Preservation Department – Item 3, LPC-25-09502

**361 Central Park West, aka 1-5 West 96th Street – First Church
of Christ, Scientist, of New York City – Individual Landmark
Borough of Manhattan**

Terrace Guardrail Update

March 19, 2025
Post Approval Amendment

Terrace Plan - Mesh Guardrail

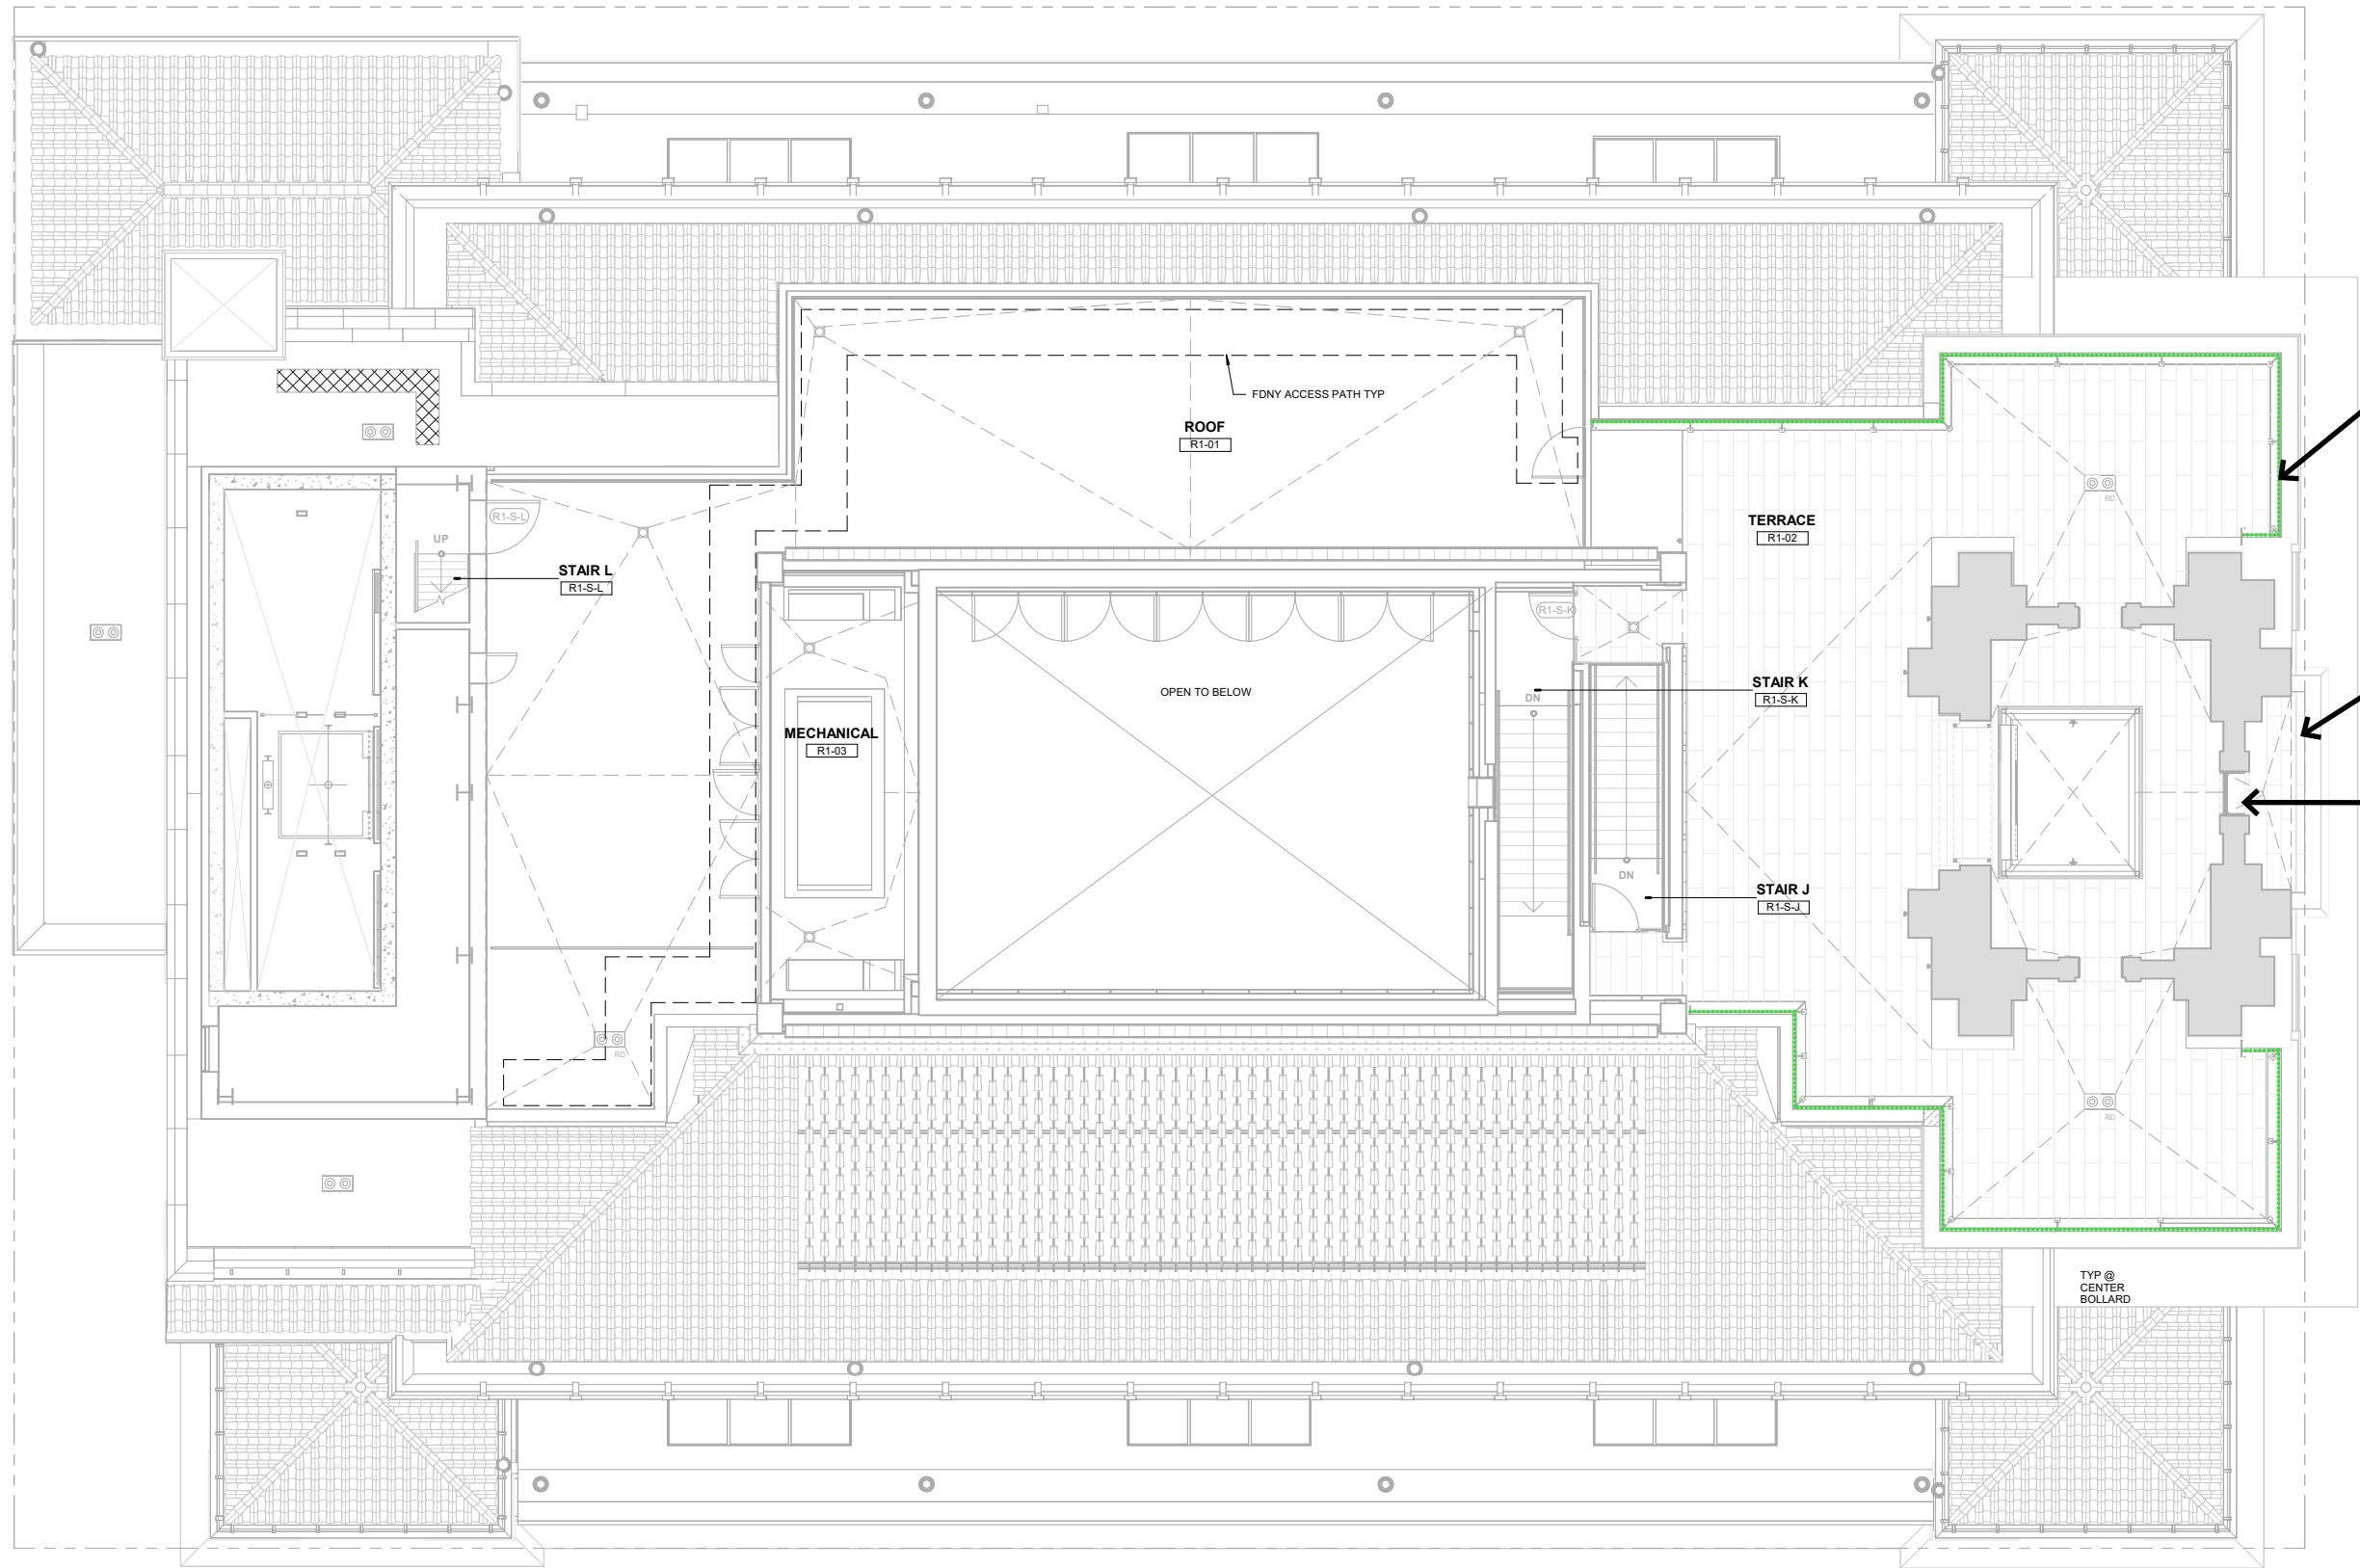
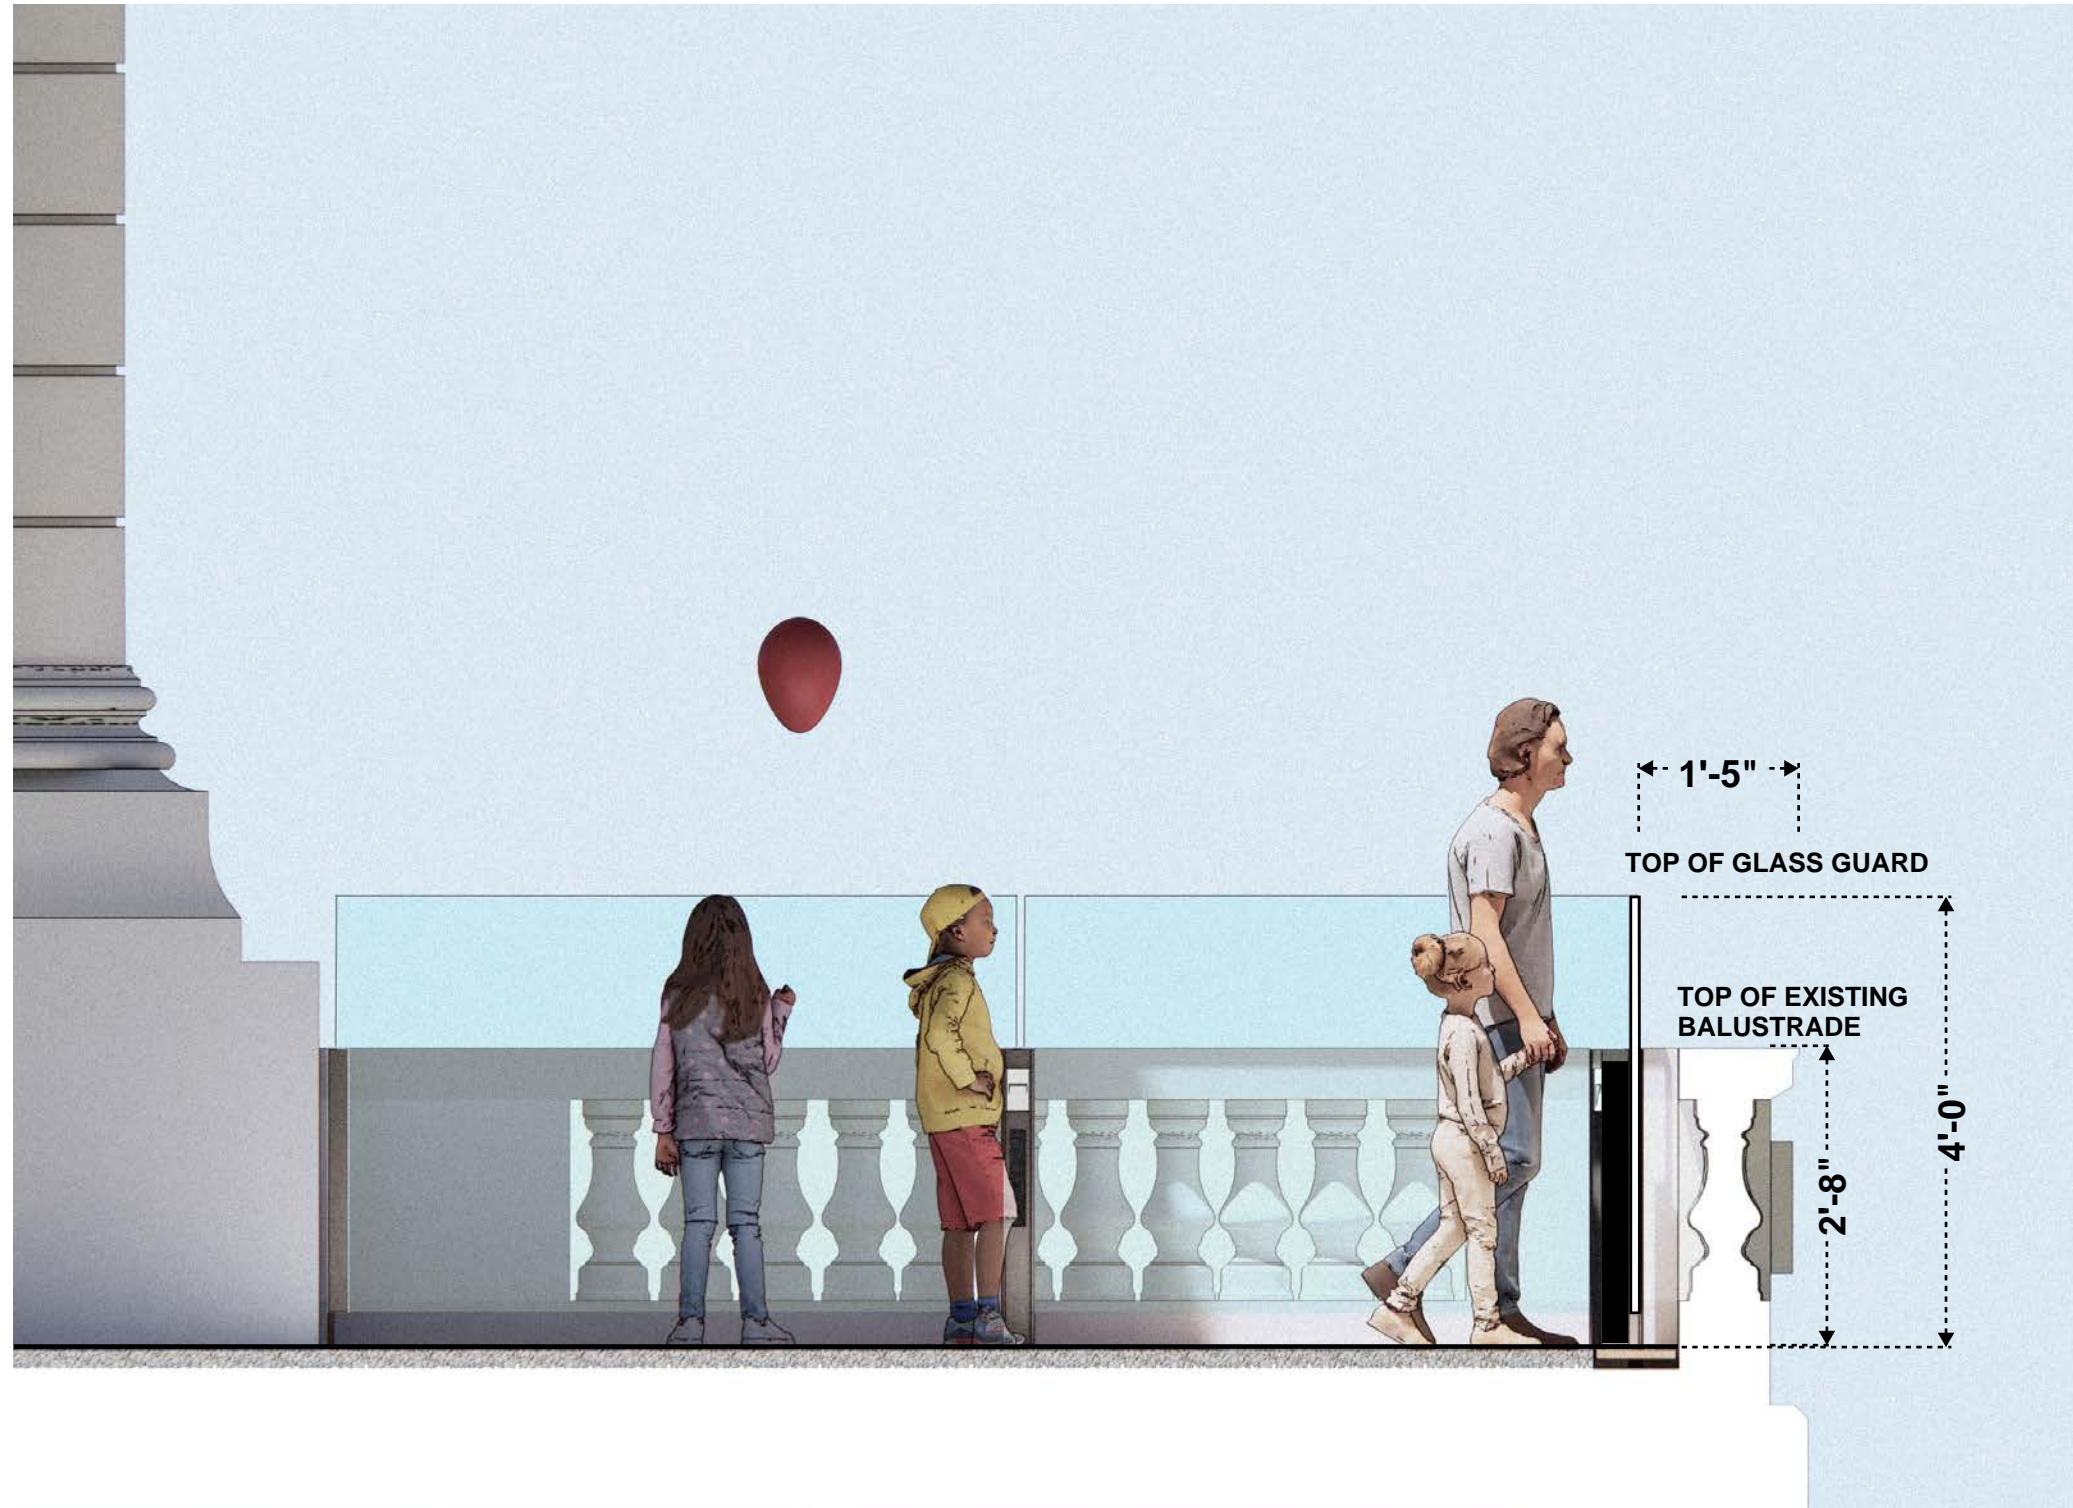
- **Increase guardrail height on the Terrace from 4'-0" to 6'-0" minimum, to address safety concerns**
- **Proposed design includes a stainless steel mesh with minimal frames integrated with the bollards and integrated light standards, simply designed**
- **Mesh is a contemporary intervention, clearly a new element, distinct from the granite tower and balustrade, with small enough apertures to deter climbing**
- **Mesh enhances the visitor experience on roof - feel breeze instead of being enclosed in glass**
- **Mesh is less reflective than glass and safer for birds**
- **Railing at center balcony is removed, a stainless steel frame and mesh gate is added to the center doorway for FDNY access only**
